CADILLAC OF NOVI SP 11-10

Public hearing on the request of Gardan LLC for Cadillac of Novi, previously known as Hummer of Novi, for recommendation of approval of the amended Special Development Option concept plan, amended Preliminary Site Plan, and amended Stormwater Management Plan. The subject property is located 41350 Grand River Avenue at the northeast corner of Grand River Avenue and Meadowbrook Road, in Section 24 of the City. The property totals 6.7 acres and the applicant is proposing building additions totaling approximately 3,200 square feet and changes to the existing parking lot layout.

Planning Review of Preliminary Site Plan

SP11-10

BUILDING DATA

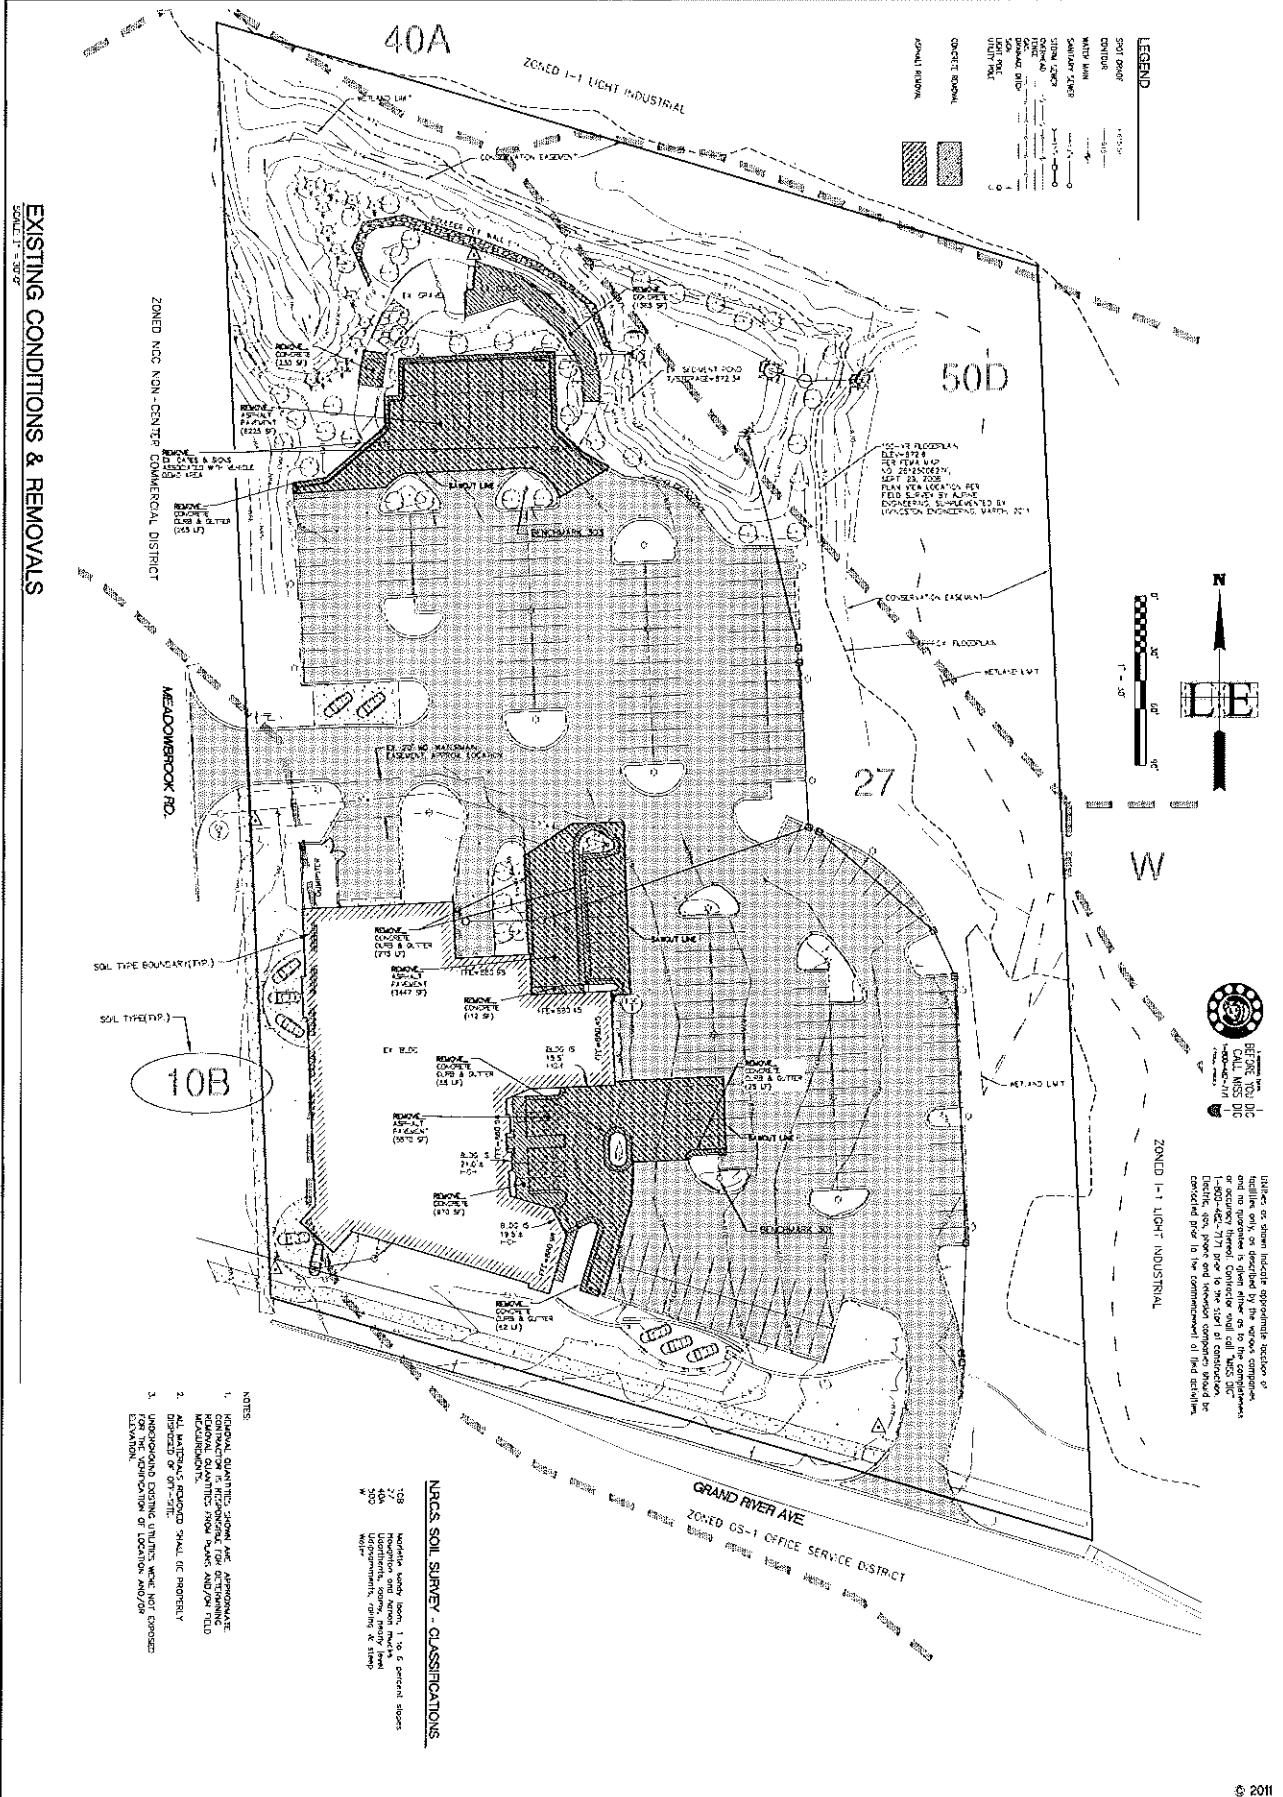
2. Floor Plan: The floor plan does not clearly dimension and provide area calculations for the proposed building additions or the sales area. **The applicant should provide area calculations for the building additions individually and for the sales area as a whole.**

| <u>Page 3, item 2</u> – | See attached floor plan area diagram. |

These numbers supersede the previous building data shown on previously submitted civil engineering cover sheet.
